MONITORING YEAR 0 ANNUAL REPORT FINAL

DYNAMITE CREEK MITIGATION SITE

Subject: DMS Comments on Dynamite Creek Mitigation Site Monitoring Year 0 Report
DMS Project Number 100125
Rockingham County, North Carolina
Contract No. 7911

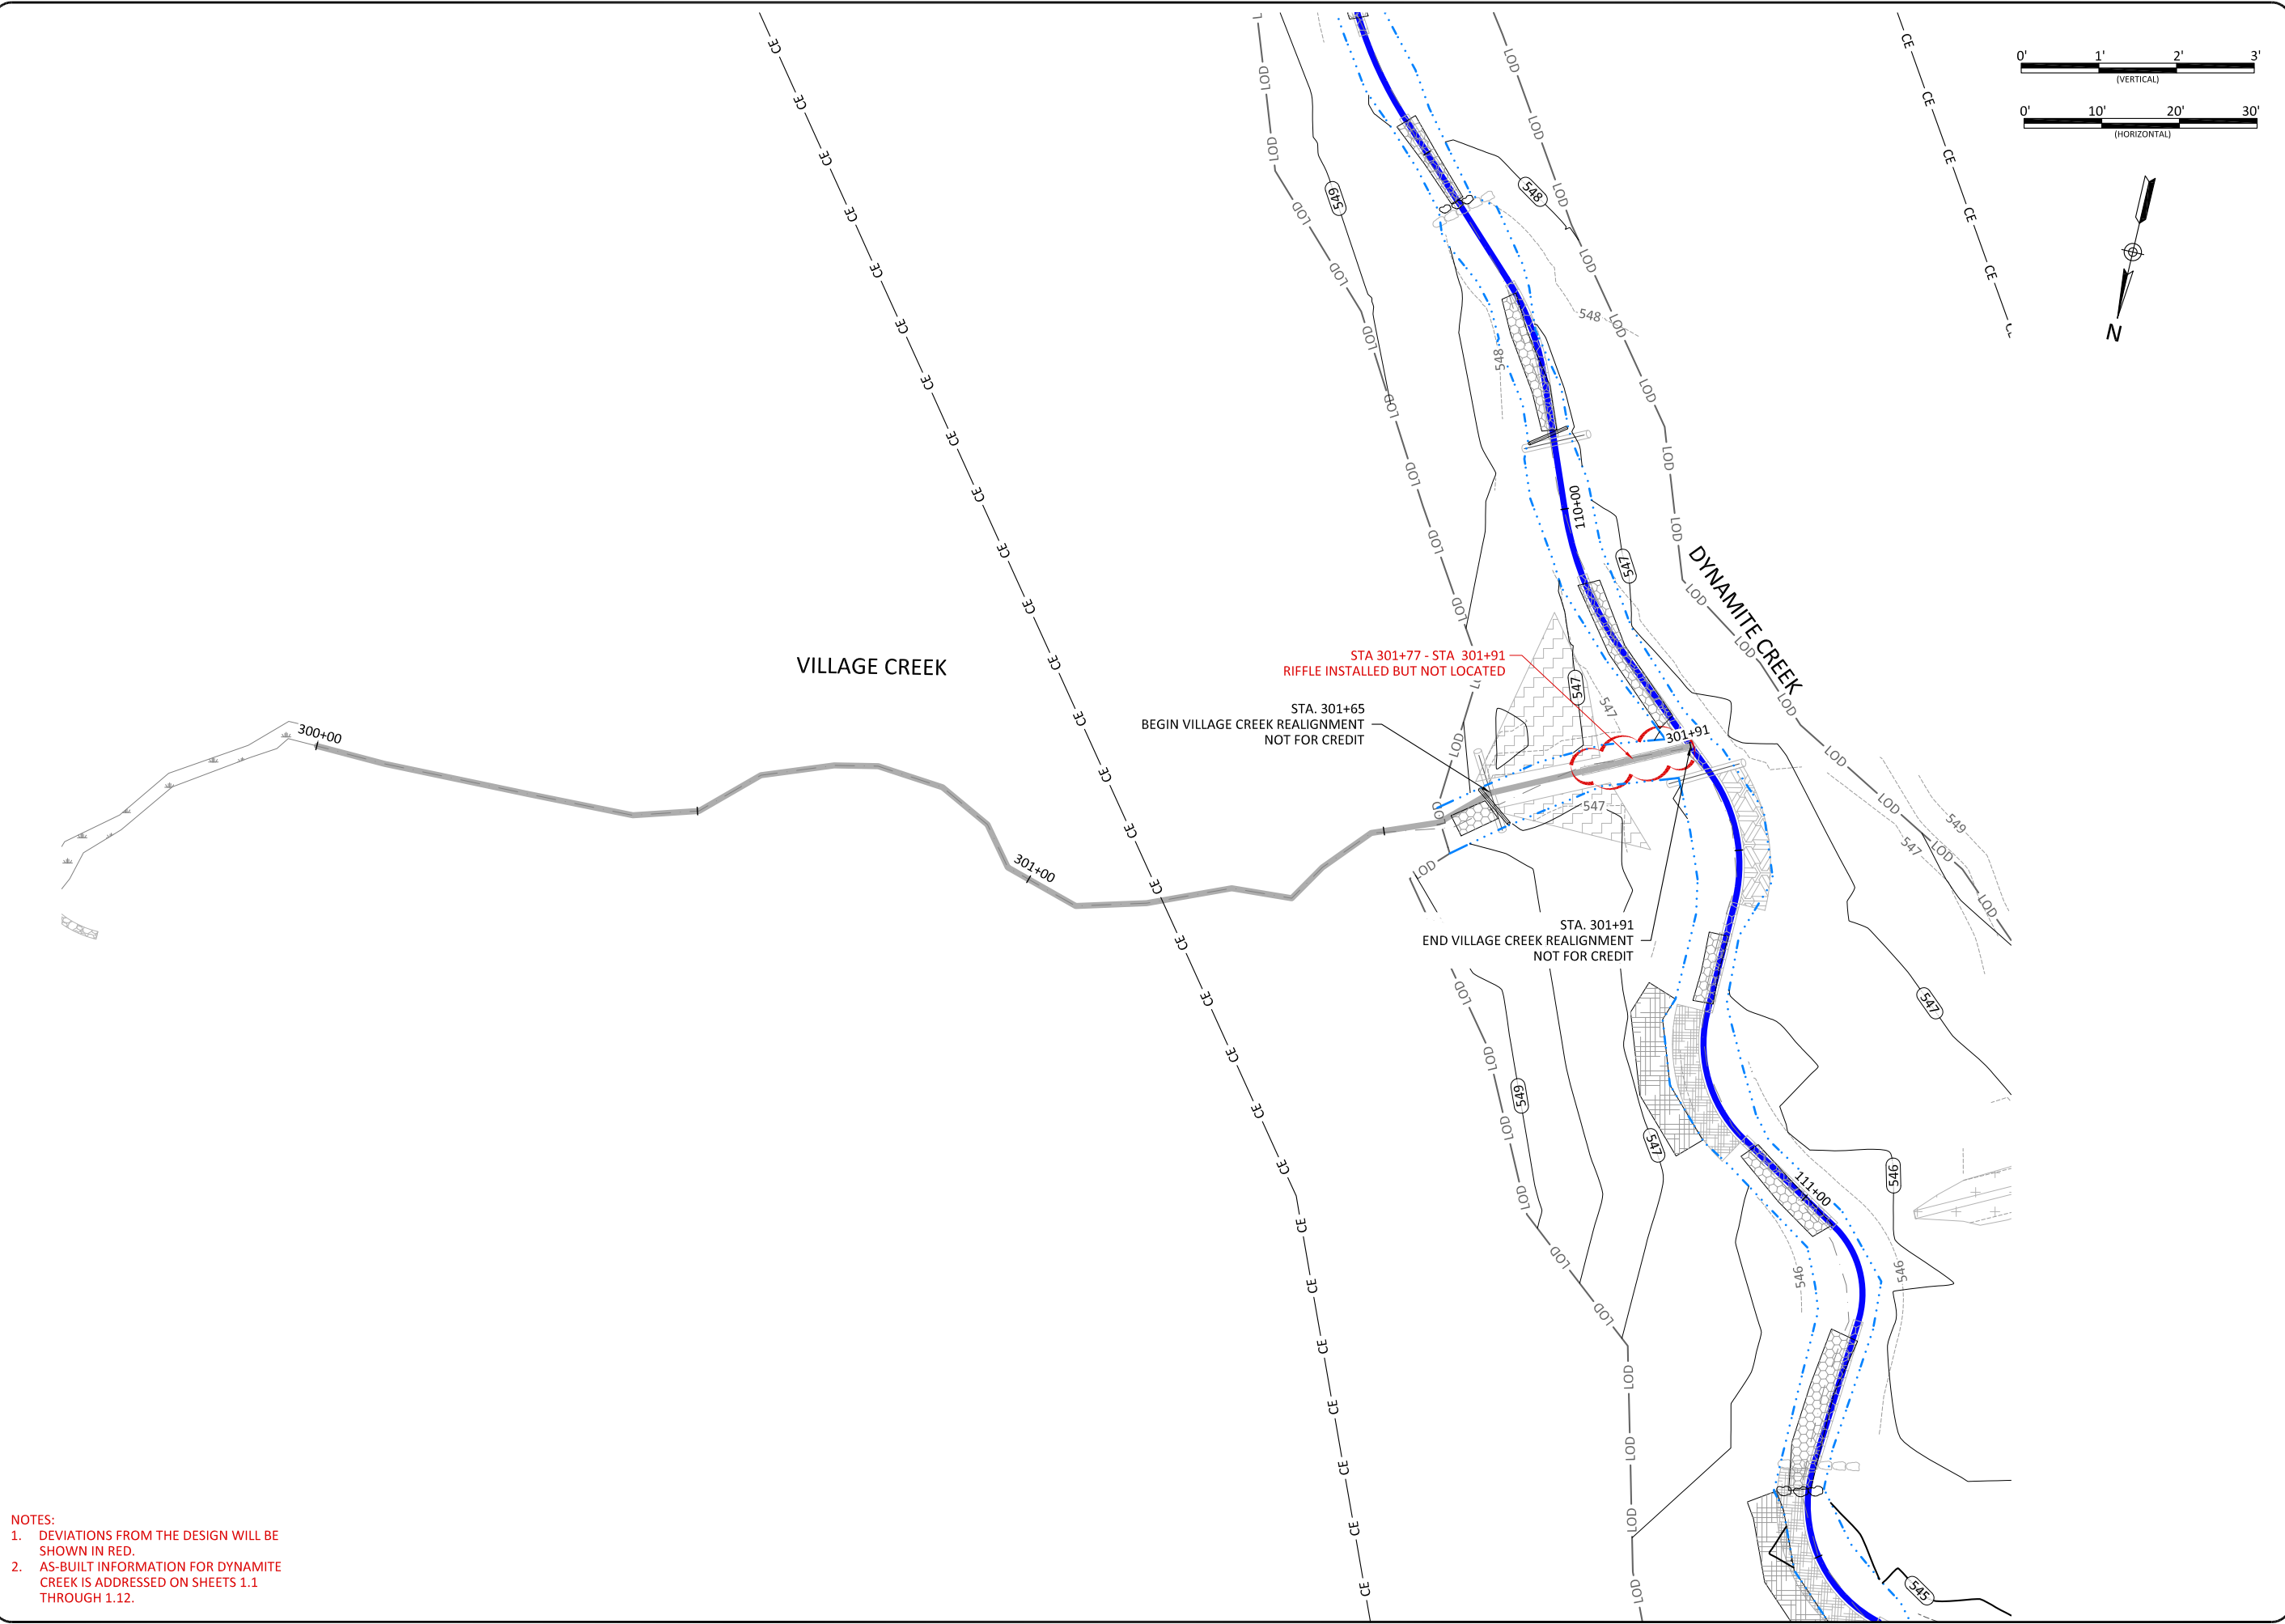
4. Sheets 1.13 & 1.14 do not appear to show an “as-designed bankfull” line. This would also assist in determining if some of the alignment callouts could be removed or should be left in the report.

The work on City and Village Creeks on Sheets 1.13 and 1.14 included stabilization along existing alignment. A full set of design parameters were not needed and design plans did not include a designed bankfull line. As such, the as-built plans also do not have an “as-designed bankfull” line. Alignment callouts were left as is.
